From: "Charles Rettiger" <crettiger@hotmail.com>  
To: "NorthAnna\_ESP@nrc.gov" <NorthAnna\_ESP@nrc.gov>  
Date: Wed, Jan 19, 2005 3:43 PM  
Subject: Reconsider the Lake Anna Early Site Permit

Alicia Williamson  
Nuclear Regulatory Commission  
Washington, DC 20555

69PR 71854

Enclosure : Oxygen Saturation Versus Temperature

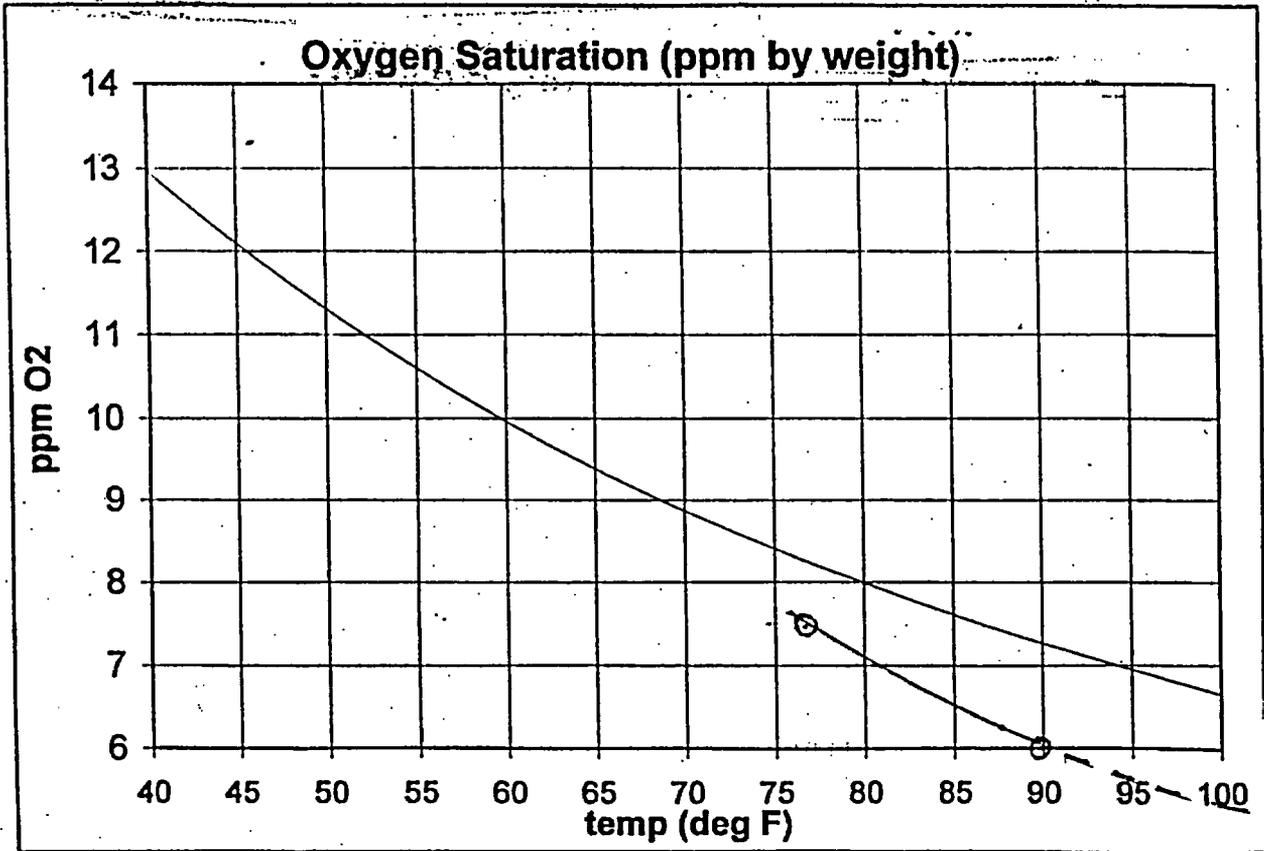
**Submitted by:** Kenneth Remmers, President Waterside Property Owners Association  
2301 Waterside Dr.  
Bumpass, VA 23024

⊙ MEASURED LEVELS for DEC 6, 2004  
with QUANTA METERS, 2004 (WTF)
